Project	<b>IEEE 802.16 Broadband Wireless Access Working Group</b> < <a href="http://ieee802.org/16">http://ieee802.org/16</a> >	
Title	<b>Changes on Sleep Mode SDLs and MSCs</b>	
Date Submitted	<b>2004-01-15</b>	
Source(s)	Chulsik Yoon, Jaeheung Kim, Kunmin Yeo ETRI 161 Gajeong-Dong, Yuseong-Gu, Daejeon, Korea	Voice: +82-42-860-6826 Fax: +82-42-860-6732 mailto: <a href="mailto:csyoon@etri.re.kr">csyoon@etri.re.kr</a>
Re:	This is a response to a Call for Comments IEEE 802.16e-03/58 on IEEE 802.16e-03/07r5	
Abstract	This document contains suggestions to change the SDLs and MSCs reflecting working groups agreements on the Sleep Mode operation.	
Purpose	The document is submitted for review by 802.16e Working Group members.	
Notice	This document has been prepared to assist IEEE 802.16. It is offered as a basis for discussion and is not binding on the contributing individual(s) or organization(s). The material in this document is subject to change in form and content after further study. The contributor(s) reserve(s) the right to add, amend or withdraw material contained herein.

# Changes on Sleep Mode SDLs and MSCs

## 2. Proposed changes on Sleep Mode operation SDLs and MSCs in IEEE

Figure 108h – MSS Awake Mode SDL Diagram

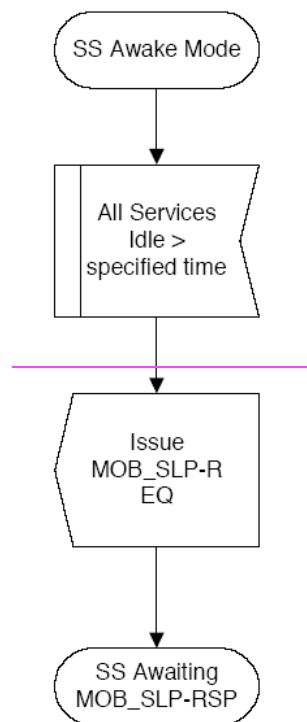
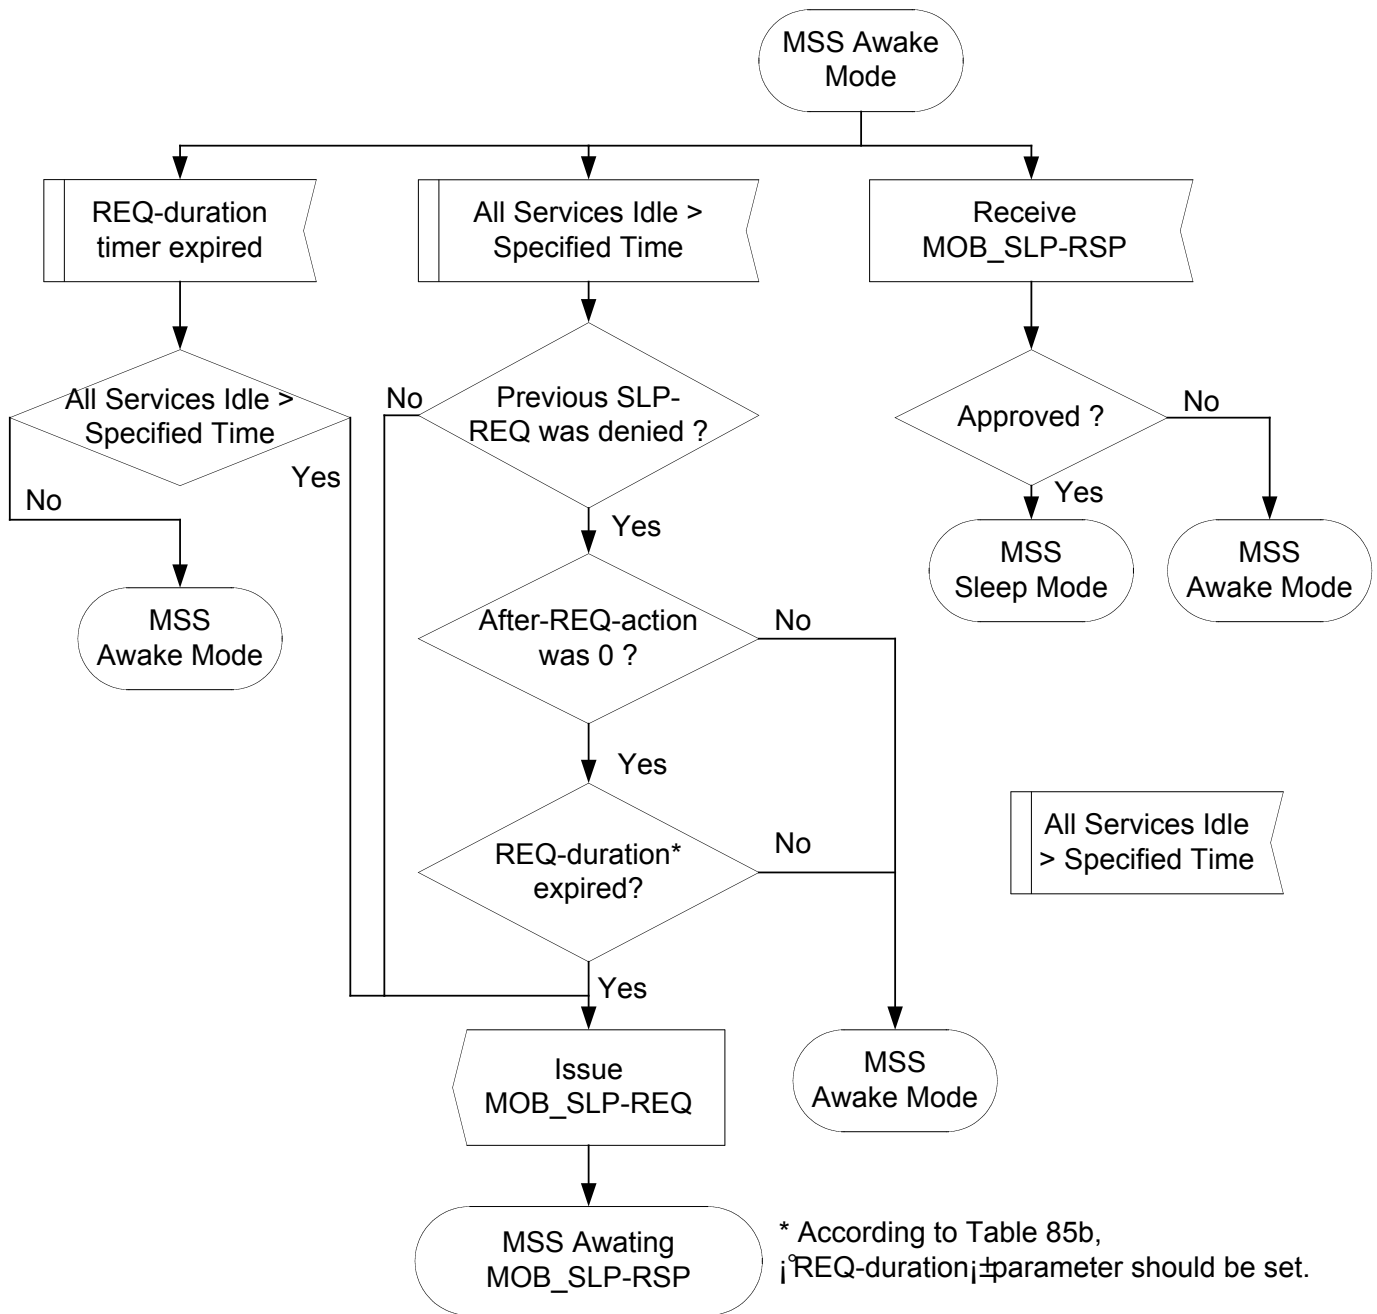
*[Replace Figure 108h to the following:]*

Figure 108i – MSS Awaiting Sleep Response SDL Diagram

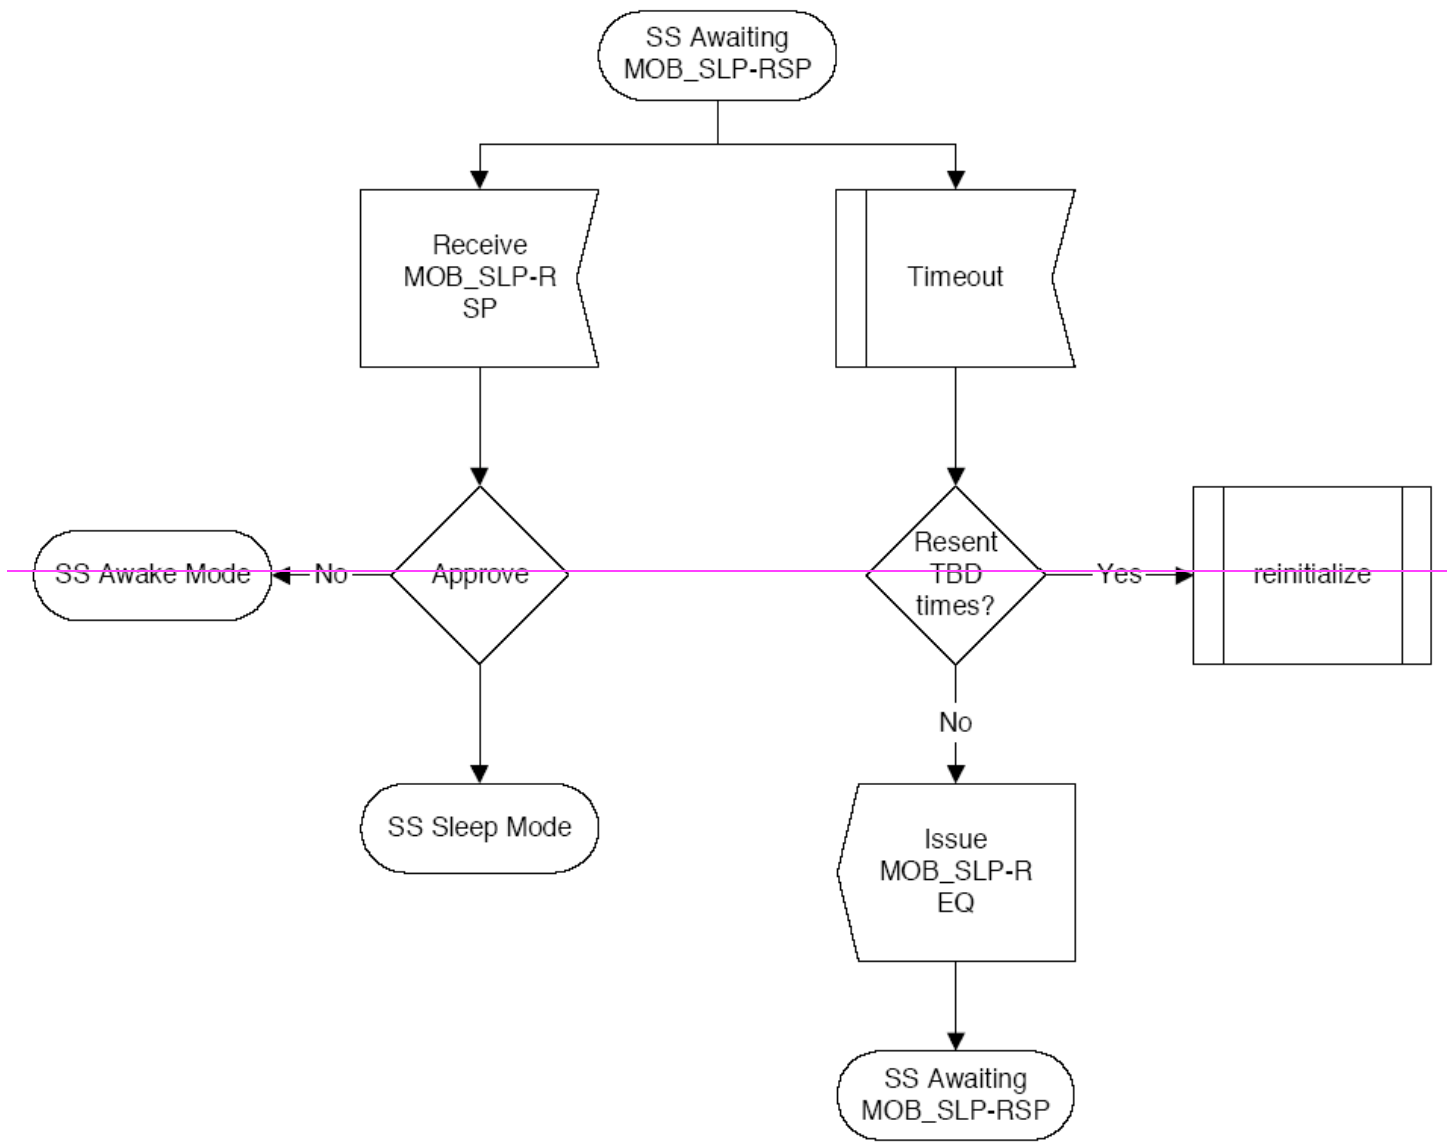
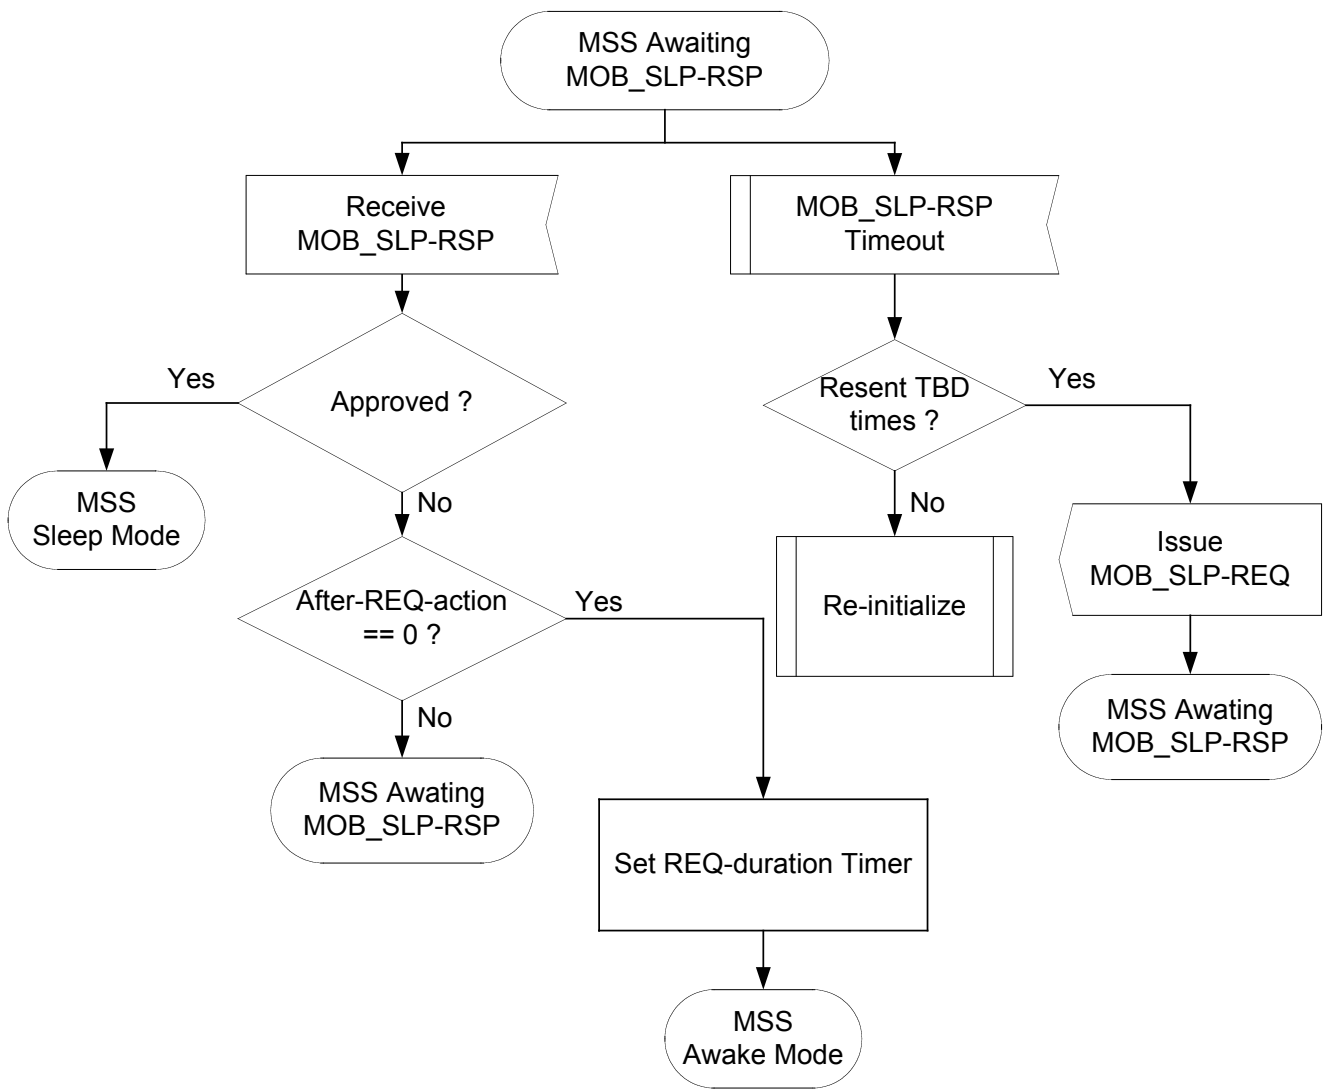
[Replace Figure 108i to the following:]

Figure 108j – Typical MSS Sleep Mode SDL Diagram

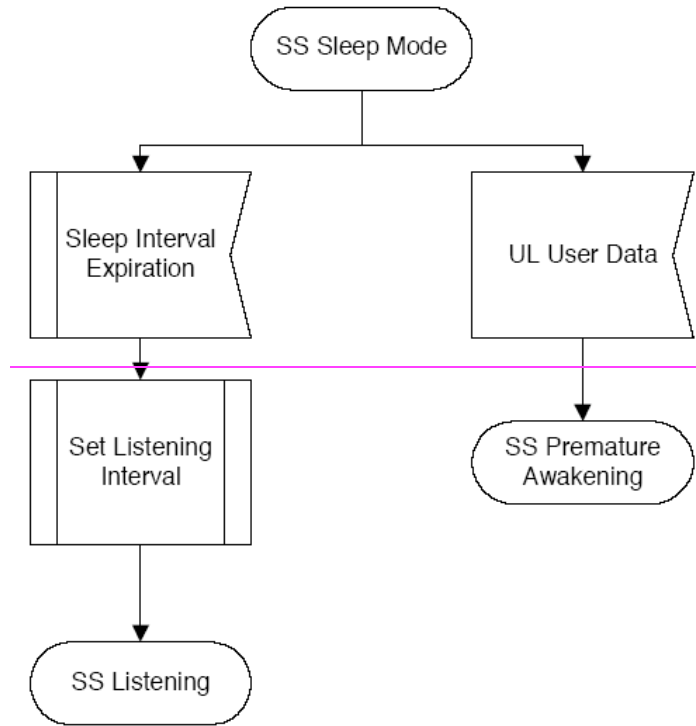
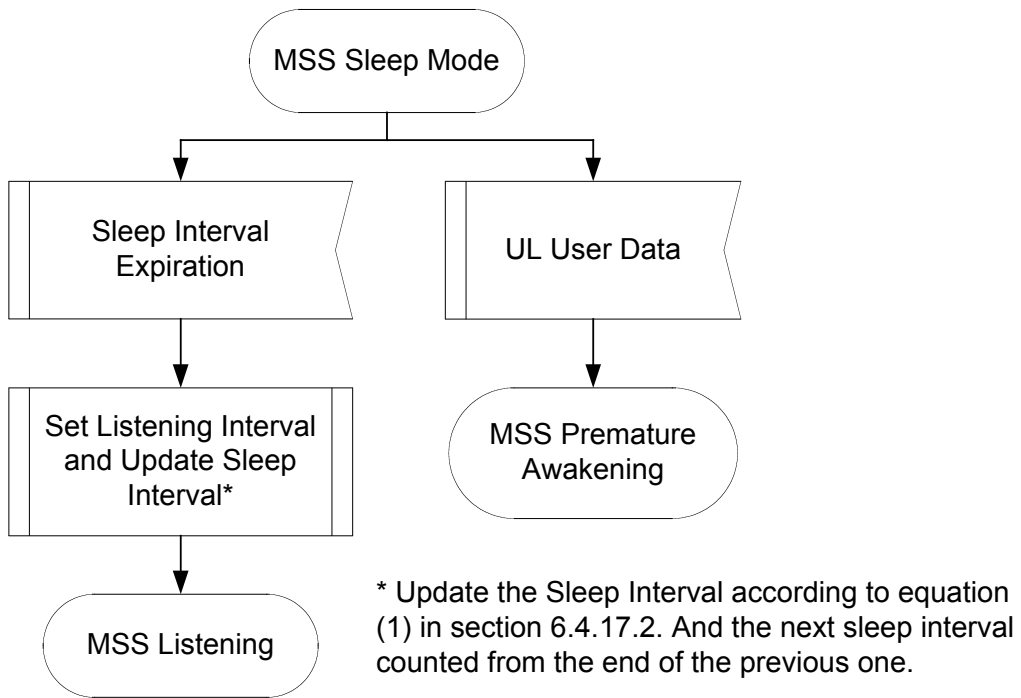
[Replace Figure 108j to the following:]  
[From:]

Figure 108k – Typical MSS Listening SDL Diagram

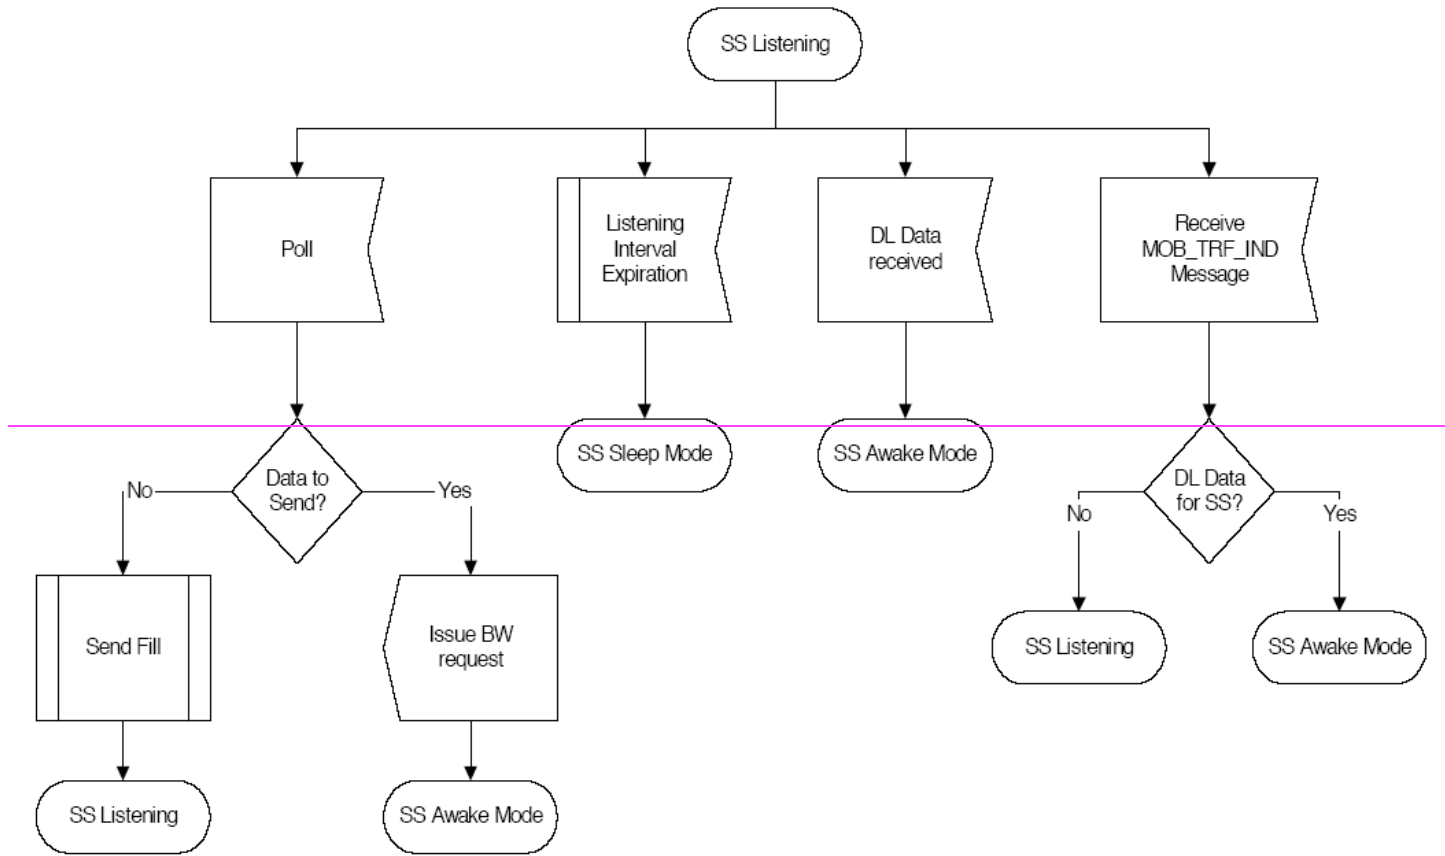
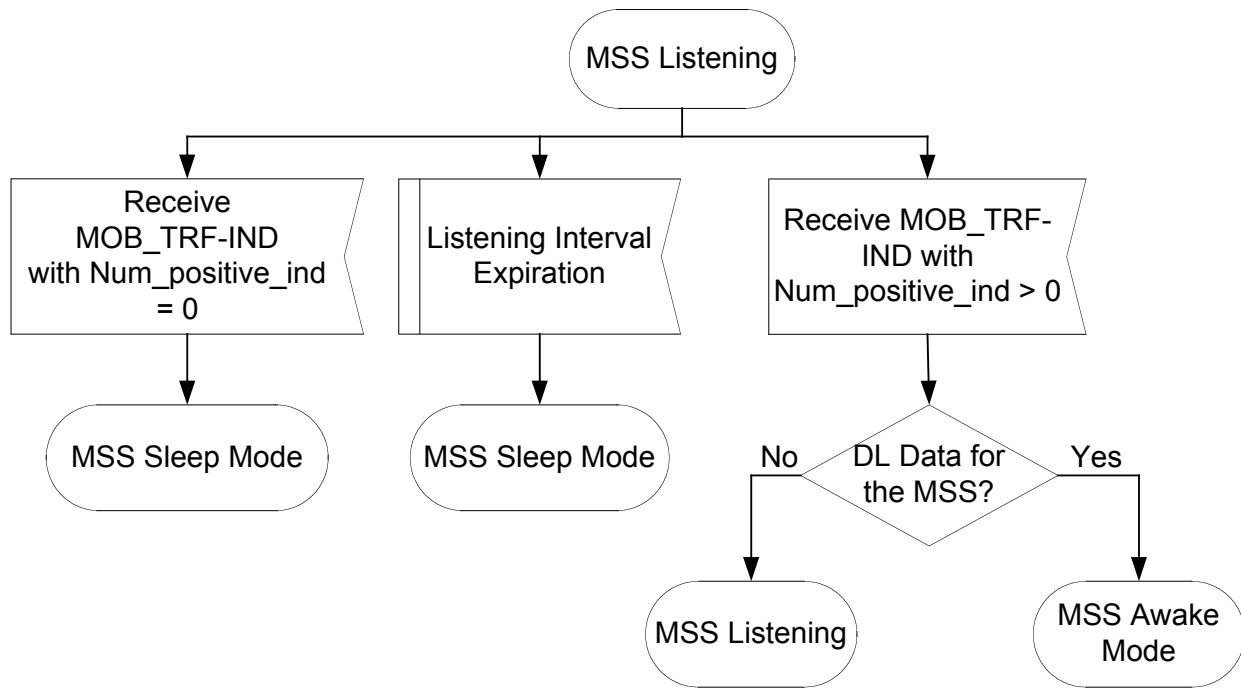
[Replace Figure 106d to the following:]  
[From:]

**Figure 108I – MSS Premature Awakening SDL Diagram**

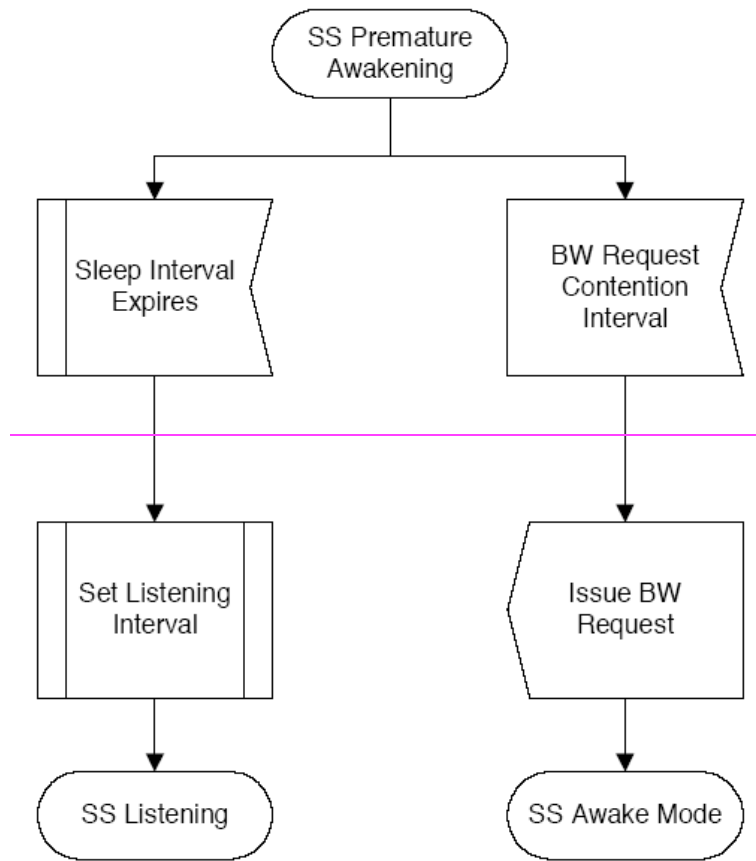
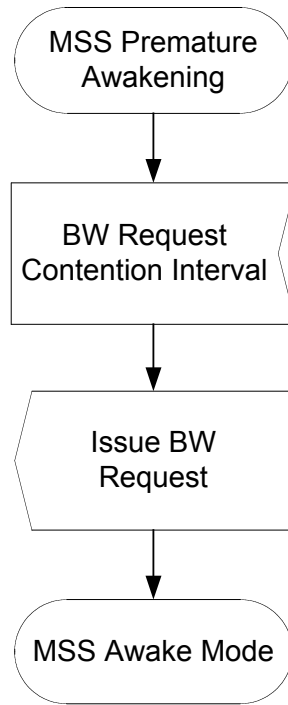
[Replace Figure 108l to the following:]  
[From:]

Figure 108m – MSS Premature Awakening SDL Diagram

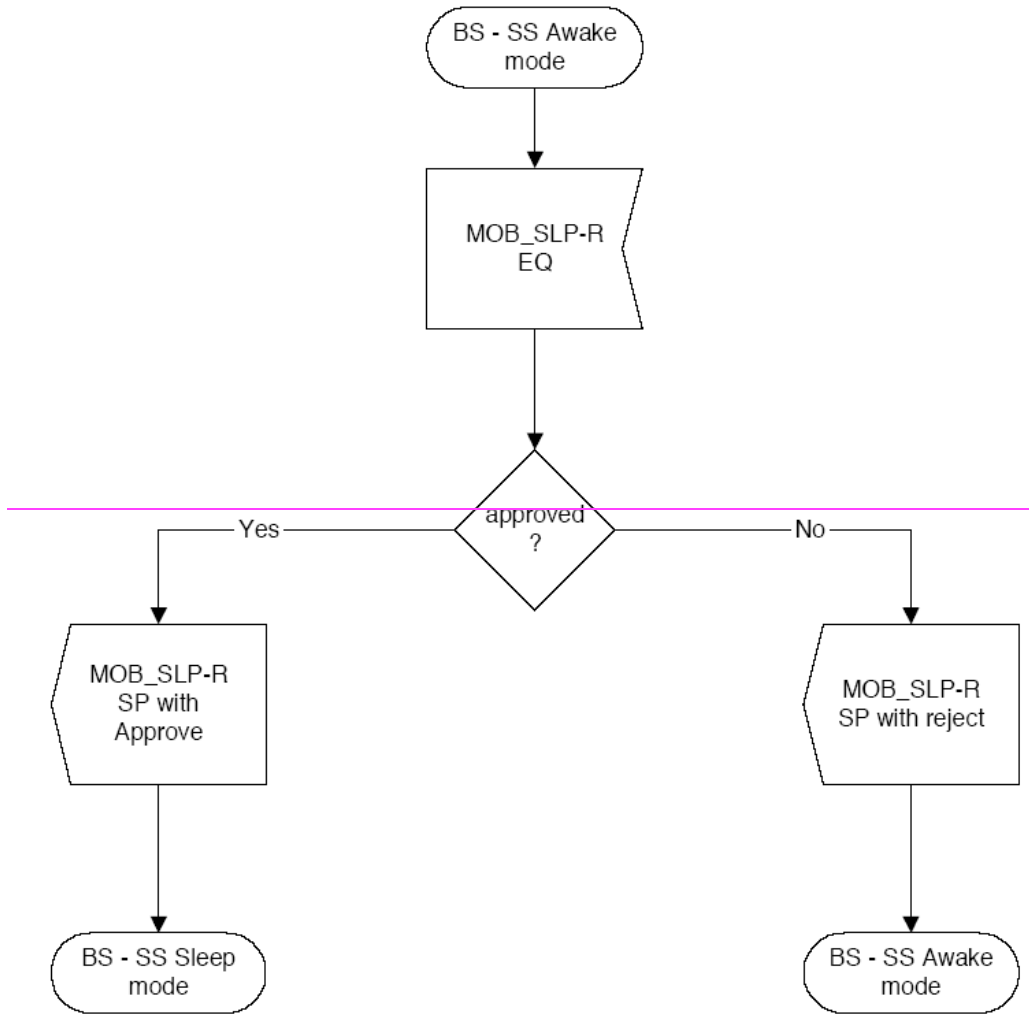
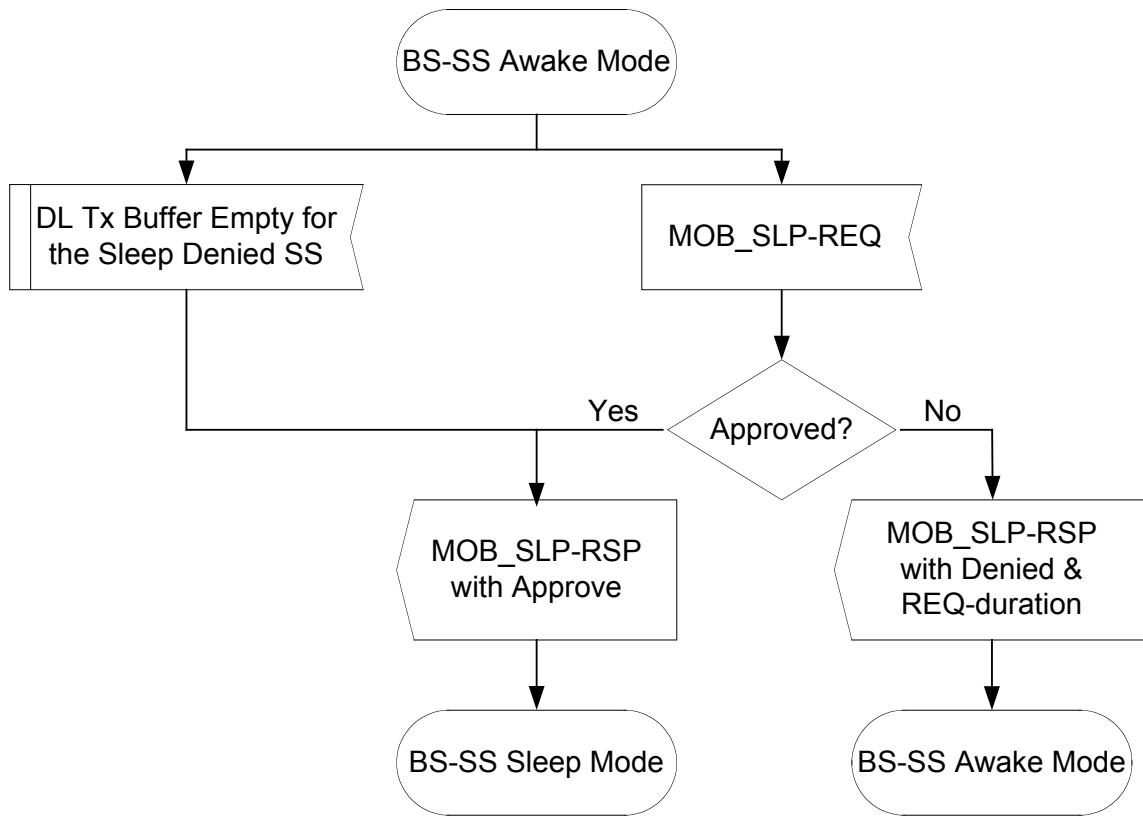
[Replace Figure 108m to the following:]  
[From:]
